**SECTION 00 91 13.01**  
**ADDENDA #01**

- A. Project Name: Royal C. Johnson Veterans Memorial Medical Center New Front Lobby & Primary Care Addition.
- B. Owner: U.S. Department of Veterans Affairs.
- C. Owner Project Number: 438-480
- D. Architect: Stone Group Architects.
- E. Architect Project Number: 201909.
- F. Date of Addendum: February 13, 2024.

**F5 BUS STOP - ROOF PLAN**  
1/4" = 1'-0"

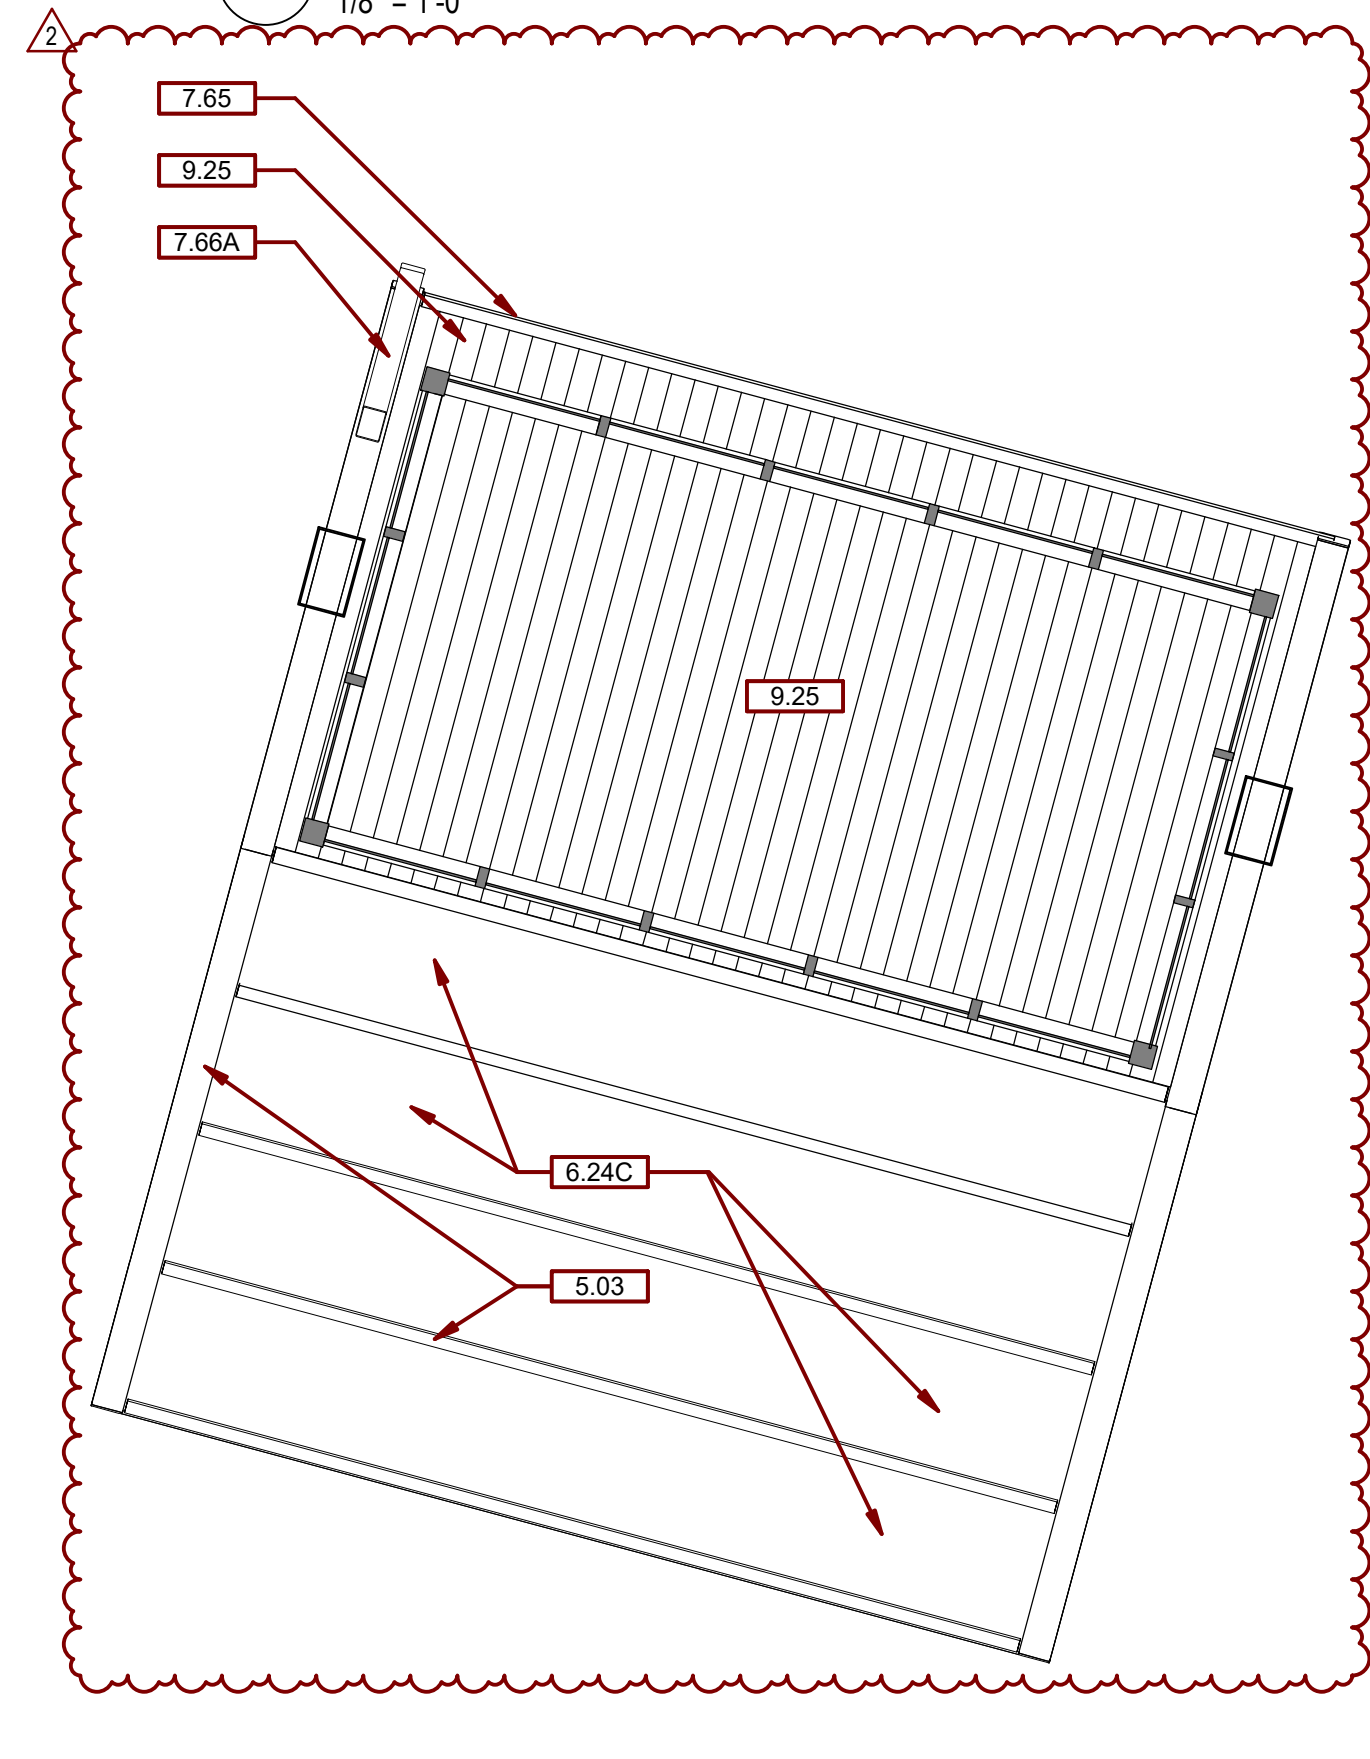
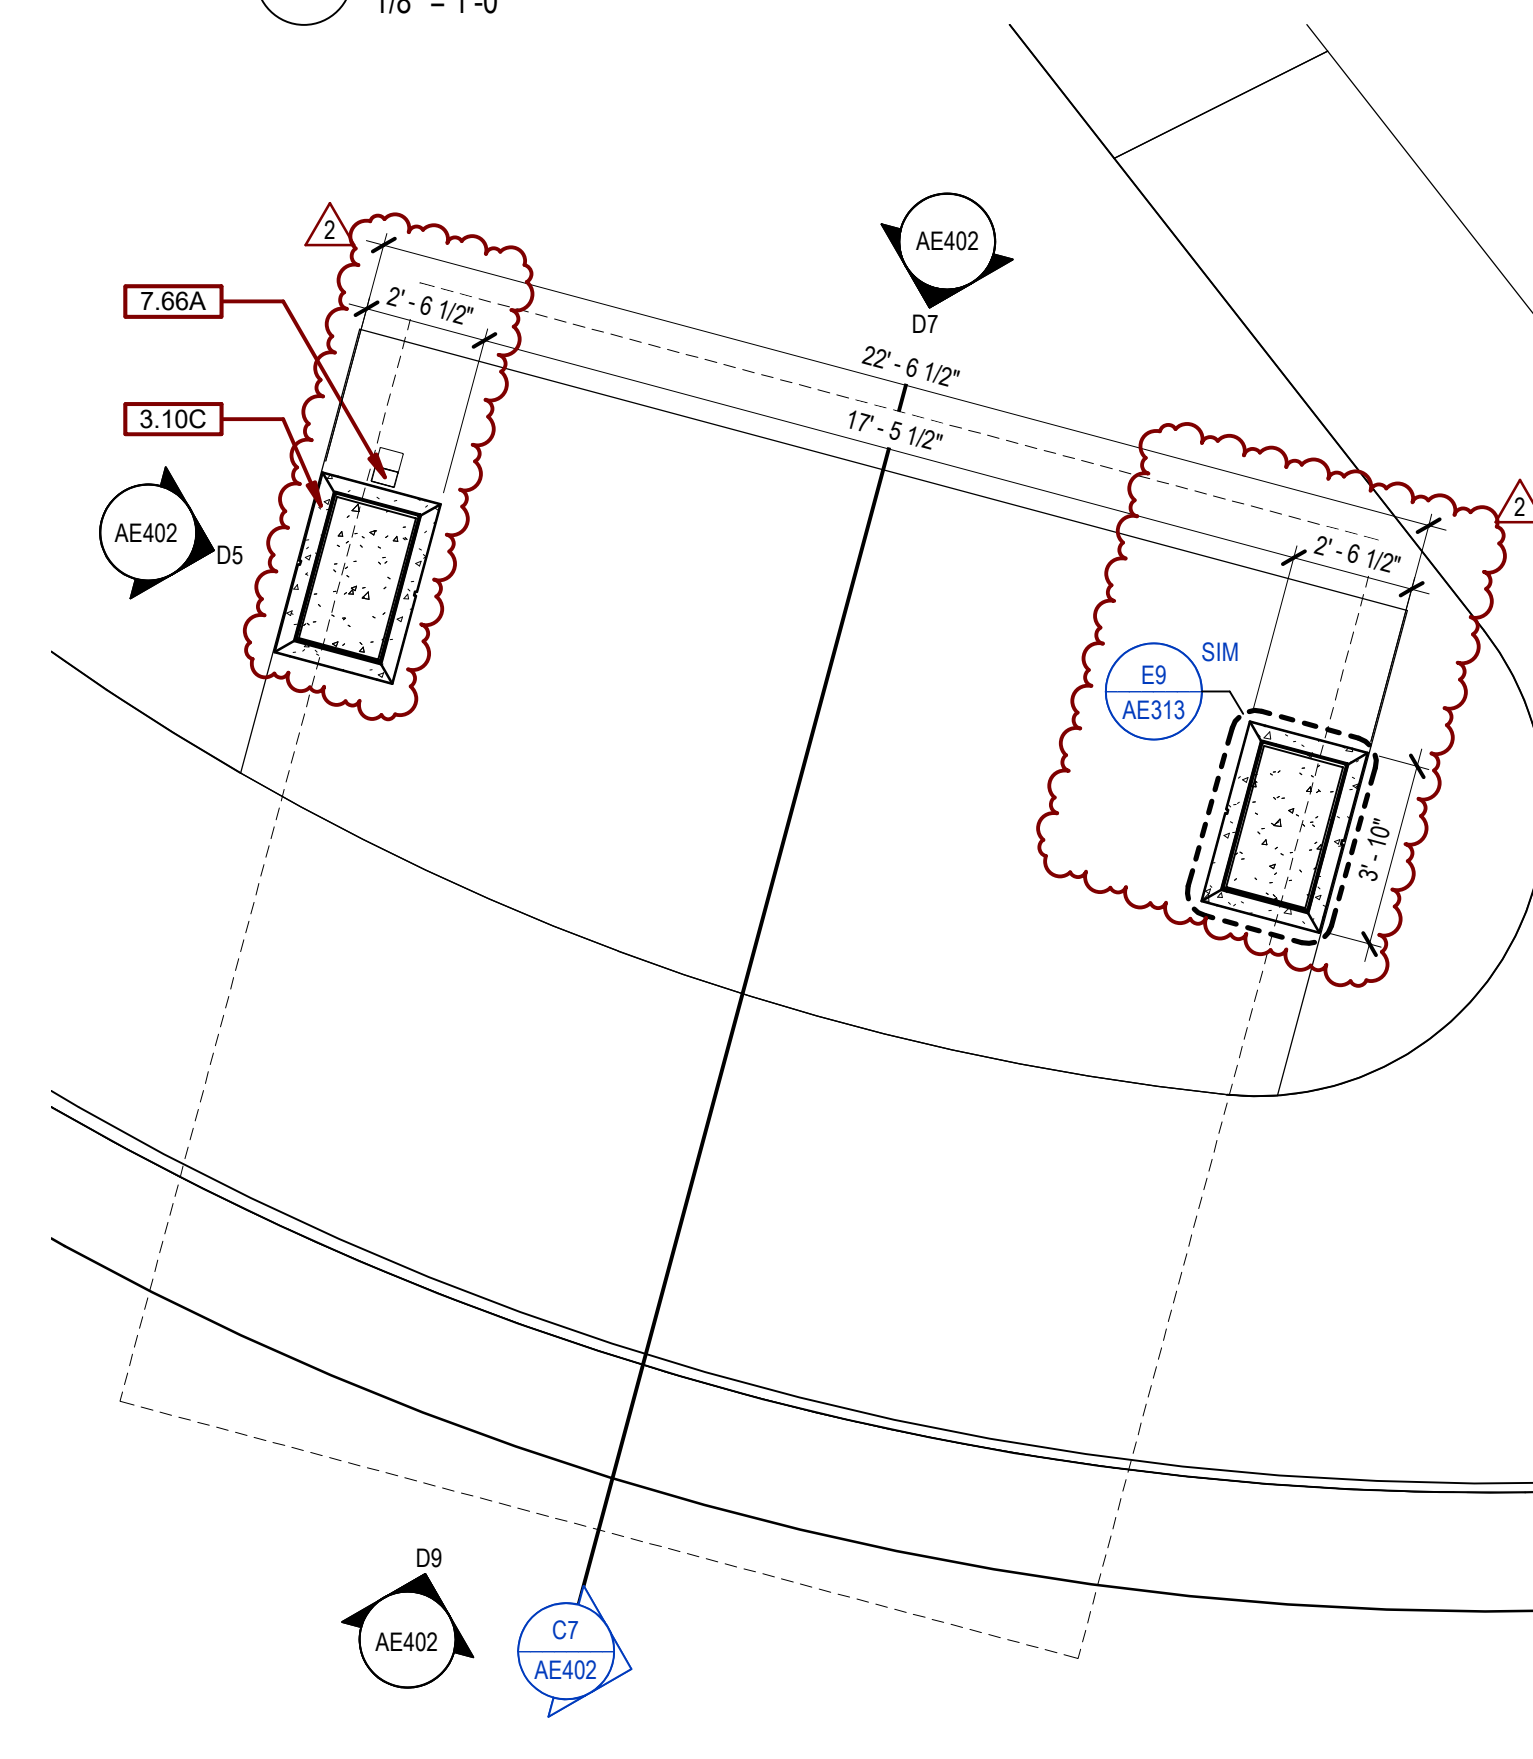
- Q. Sheet AE402 - BUS STOP DETAILS (reissued).
  - 1. Updates to detailing and clarifications for deduct alternate requirements.

**C1 SECTION DETAIL - ROOF FLASHING AT EXISTING & LOBBY CORRIDOR**  
1 1/2" = 1'-0"

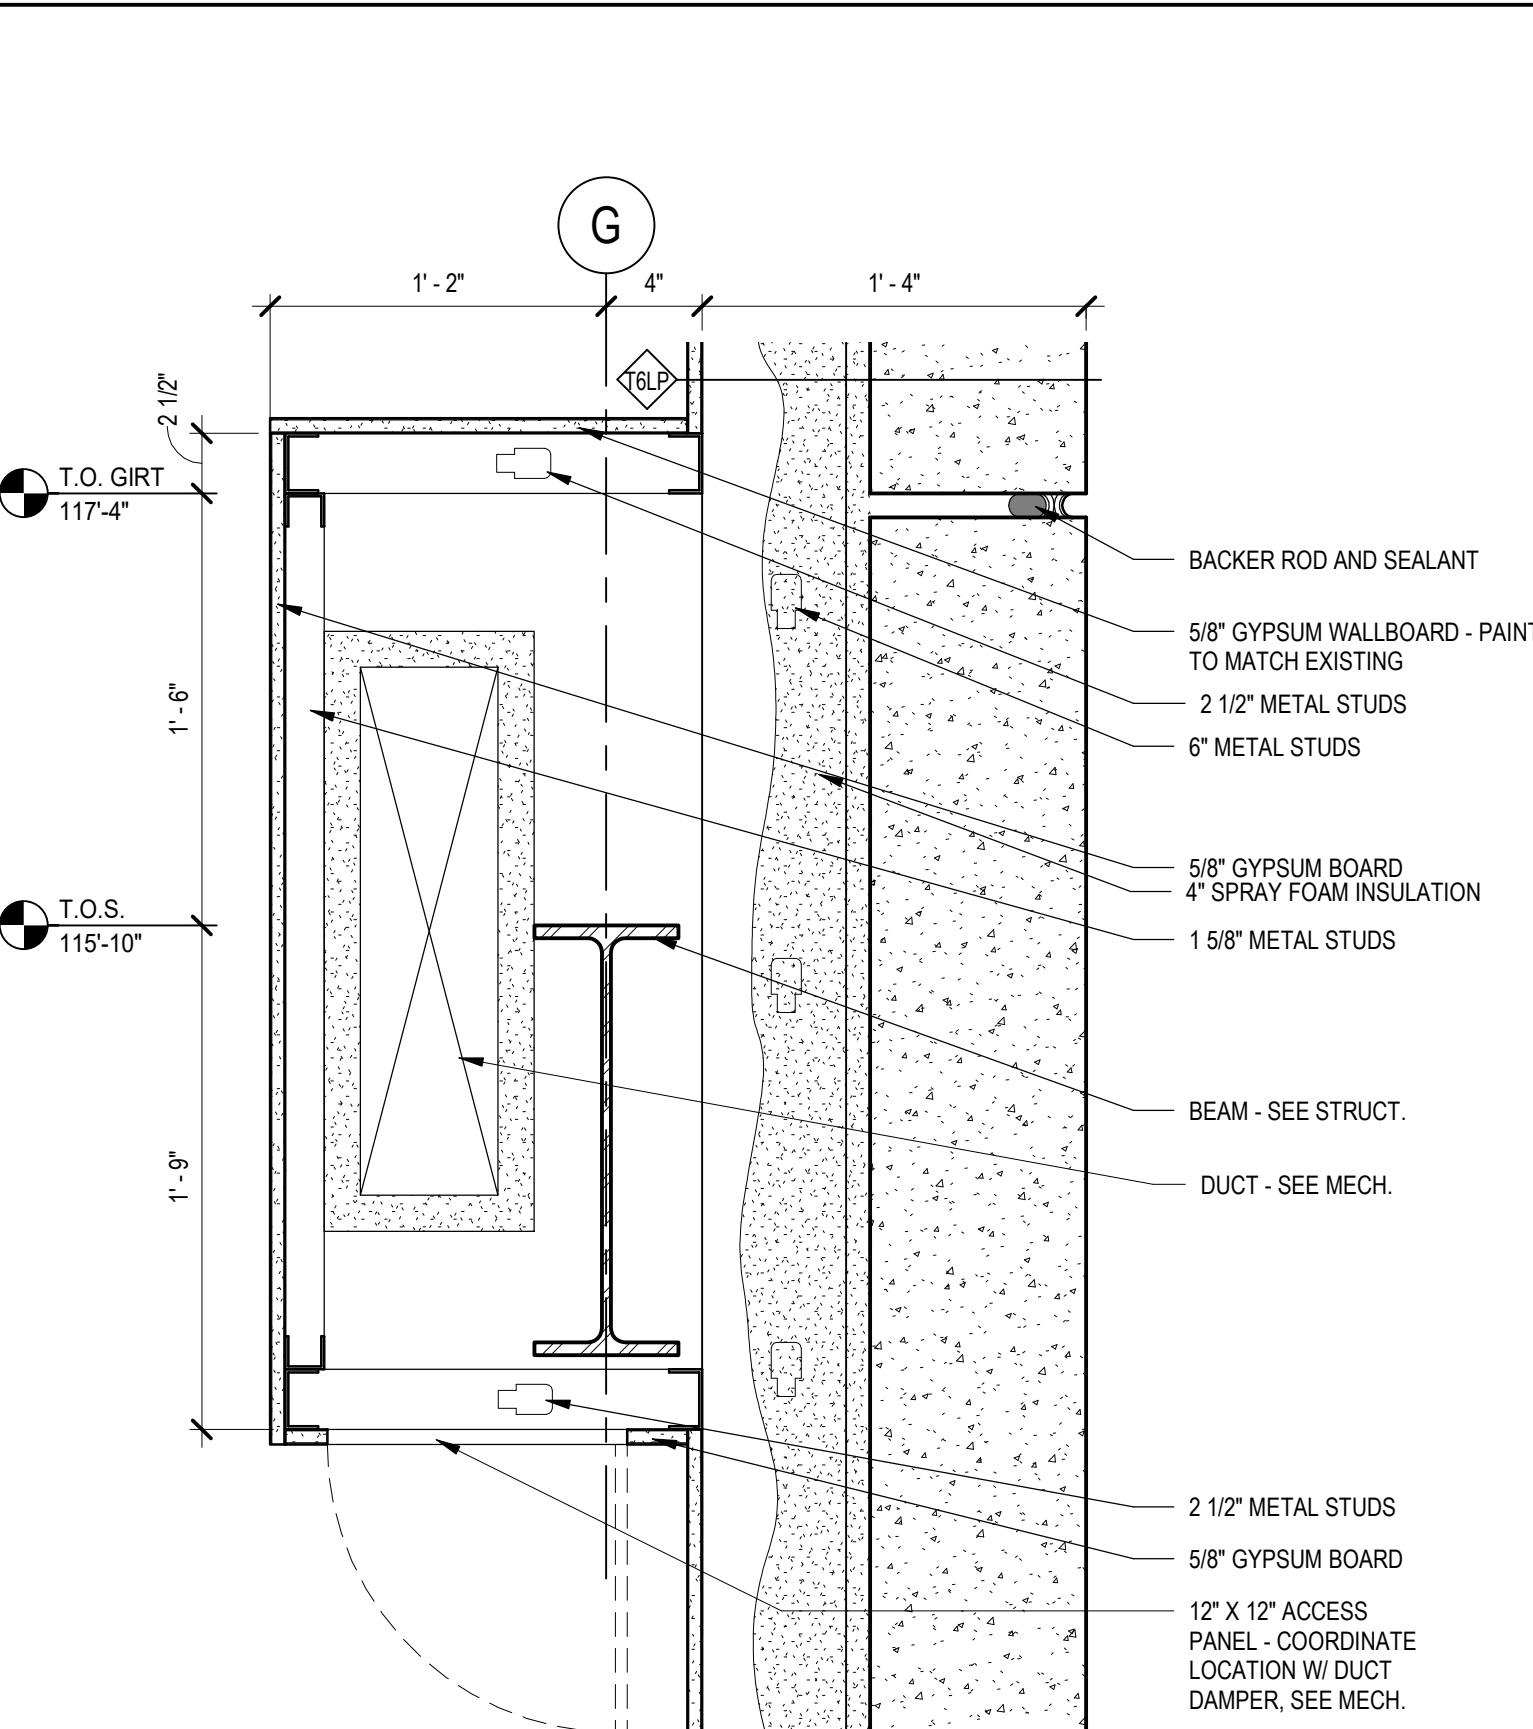
- R. Sheet AE502 - Details (reissued).
  - 1. Revisions to details C1, E1, F1 and F3.

**ROOF TYPES**

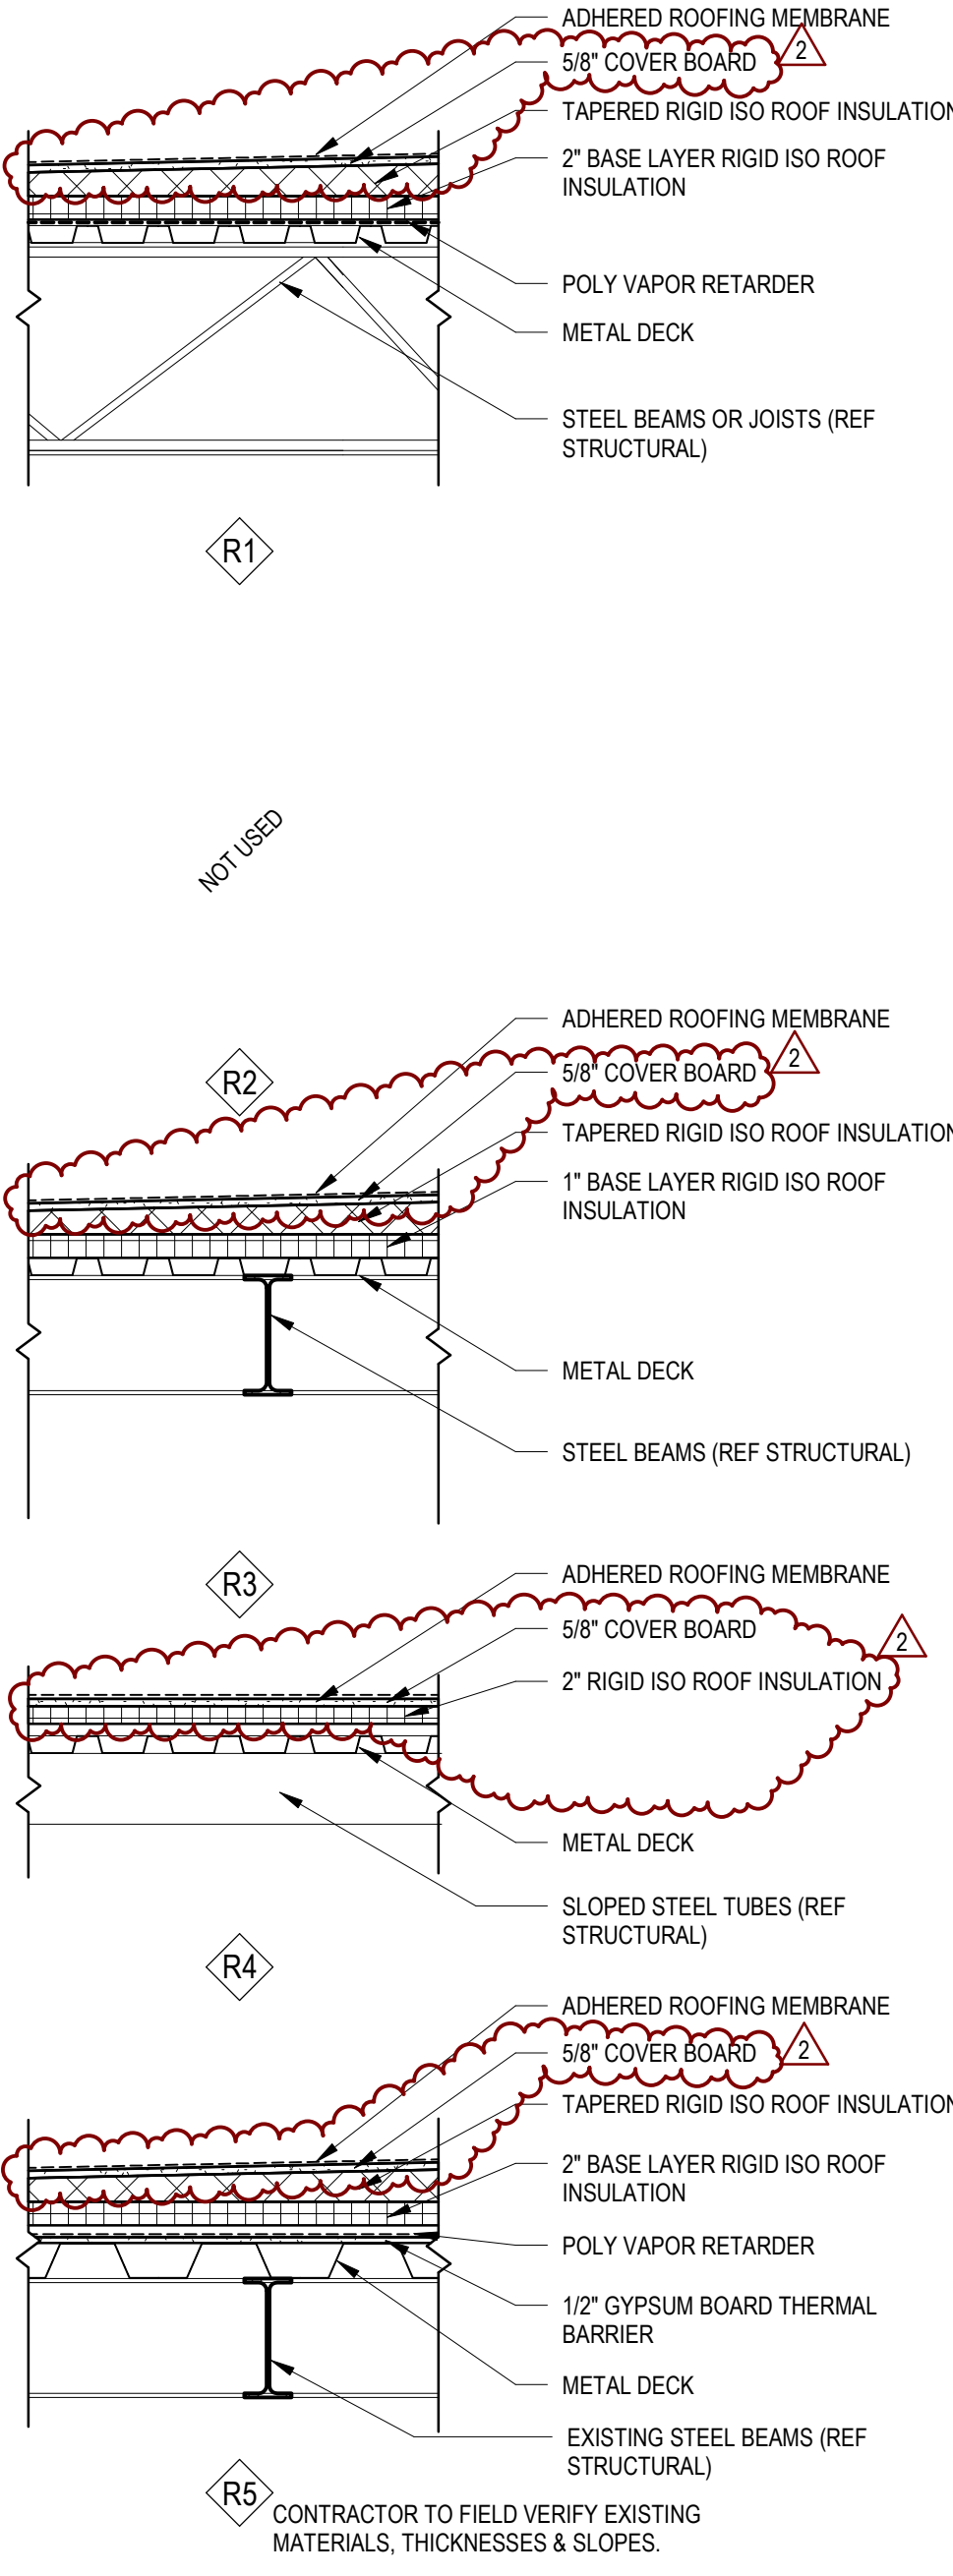
- S. Sheet AE601 - Schedules (reissued).
  - 1. Roof Types - Added cover board to roof types R1, R3, R4, and R5.
